The Commission has issued the enclosed Amendment No. 74 to Facility Operating License No. DPR-59 for the James A. FitzPatrick Nuclear Power Plant. The amendment consists of changes to the Technical Specifications in response to your request dated May 25, 1983. The changes were necessitated as a result of new fuel loaded during the current refueling outage (Reload 5) to support power operation in Cycle 6.

The amendment revises the Minimum Critical Power Ratio Operating Limits to accommodate the new fuel; adds additional Rod Block Monitor Trip Level Settings to facilitate control rod withdrawals; and, deletes references to fuel types and the supporting analyses for fuel removed from the core.

Amendment No. 74  
License No. DPR-59

SAFETY EVALUATION BY THE OFFICE OF NUCLEAR REACTOR REGULATION  
SUPPORTING AMENDMENT NO. 74 TO FACILITY OPERATING LICENSE NO. DPR-59

Figure 3.1-2

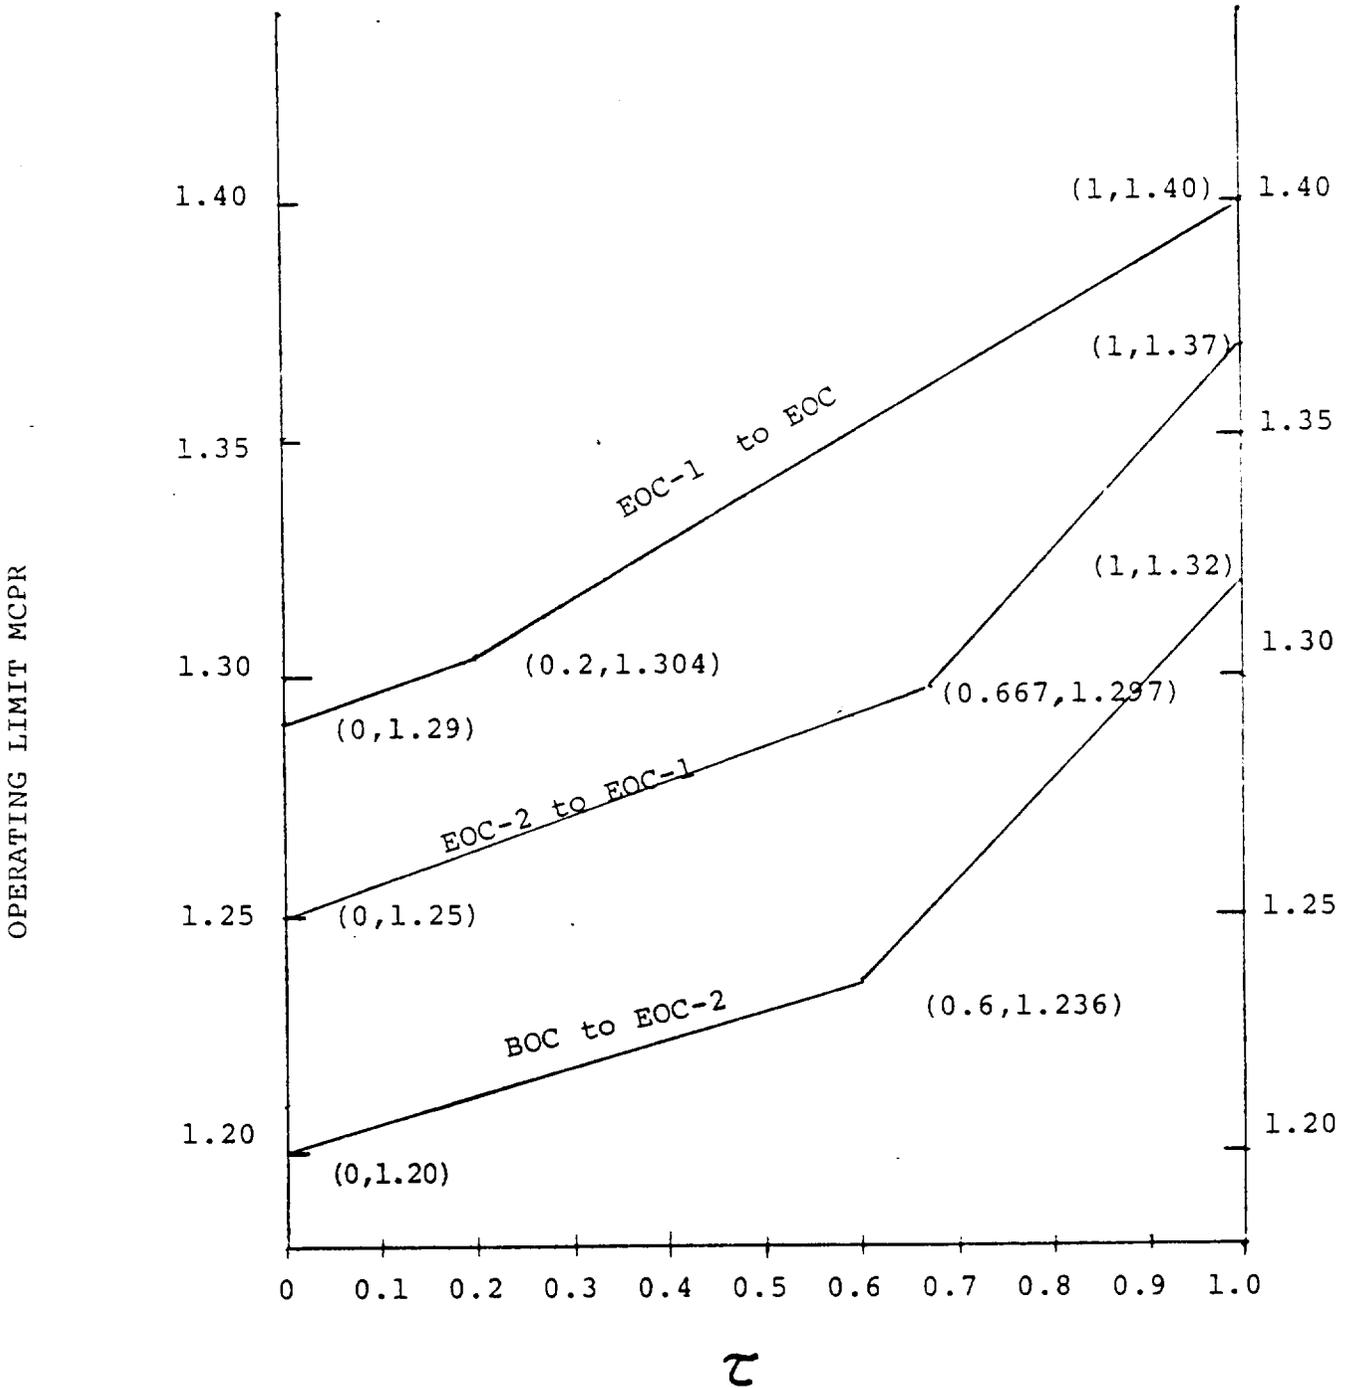
The two additional equations for the Rod Block Monitor setpoints are added in Specification 3.1.B and in the Notes for Table 3.2-3. These are acceptable. Figure 3.1-2 has been altered to reflect the MCPR operating limit as a function of  $T$  for the new cycle and MAPLHGR limits for the new fuel (Type P8DRB299) are added in Figure 3.5-10. These changes are acceptable.

2. If requirement 4.1.E.1 is not met (i.e.  $\tau_B < \tau_{AVE}$ ) then the Operating Limit M CPR values (as a function of  $\tau$ ) are as given in Figure 3.1-2.

Figure 3.5-10

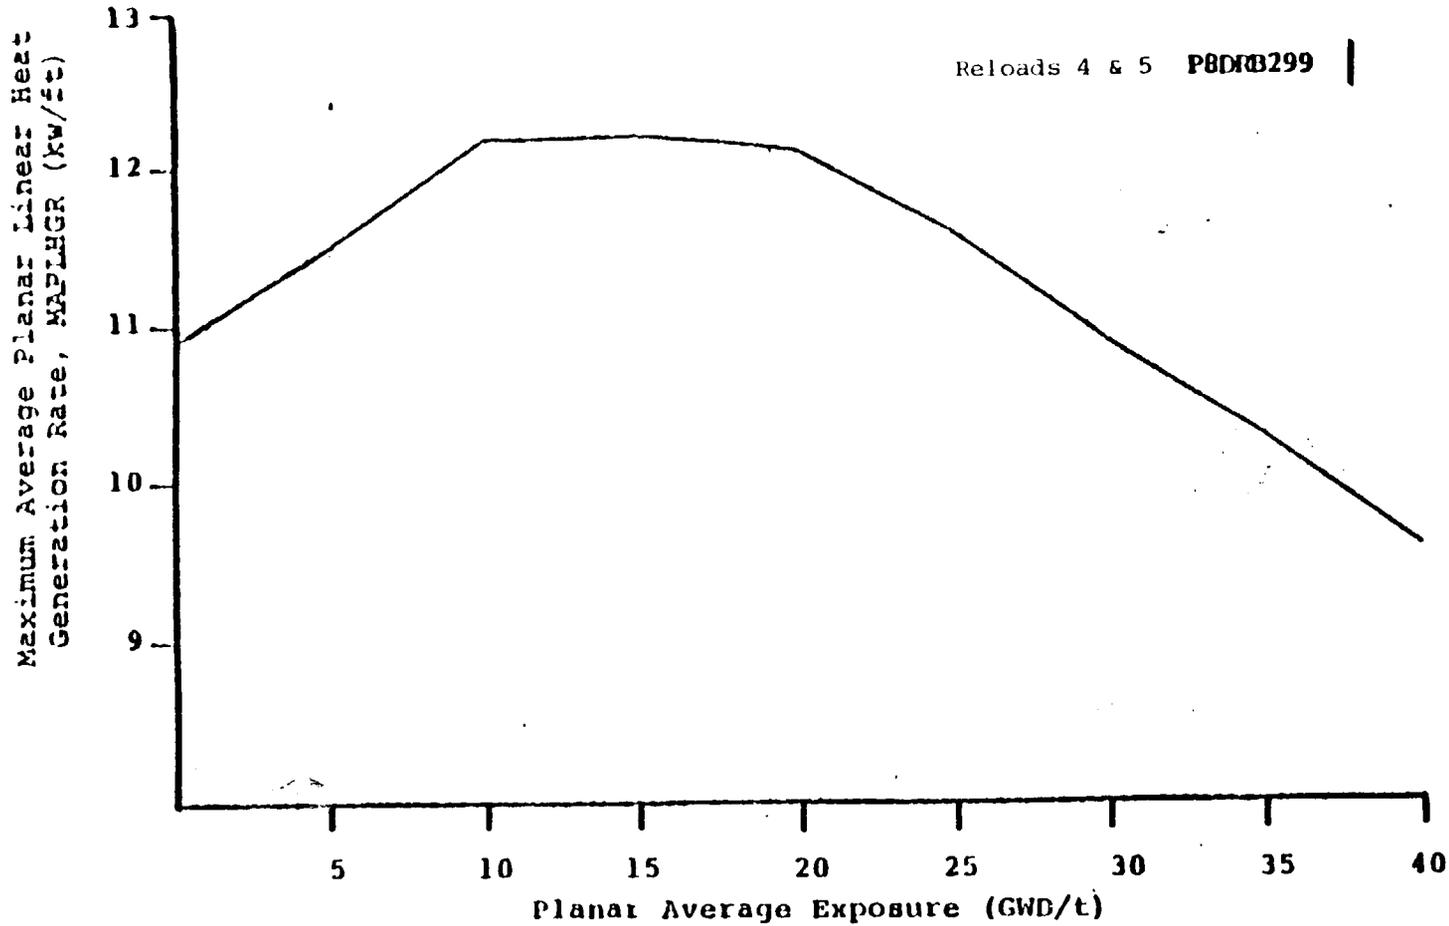
The maximum average planar linear heat generation rate (MAPLHGR) for the fresh fuel labeled Type P8DRB299 is identical to the previously approved MAPLHGR limit for the existing Cycle 5 fuel of the same type. We thus find the MAPLHGR limit acceptable for Cycle 6.

The APIHGR for each type of fuel as a function of average planar exposure shall not exceed the limiting value shown in Figures 3.5-6 through 3.5-10. If anytime during reactor power operation greater than 25% of rated power it is determined that the limiting value for APIHGR is being exceeded, action shall then be initiated within 15 minutes to restore operation to within the prescribed limits. If the APIHGR is not returned to within the prescribed limits within two (2) hours, an orderly reactor power reduction shall be commenced immediately. The reactor power shall be reduced to less than 25% of rated power within the next four hours, or until the APIHGR is returned to within the prescribed limits.
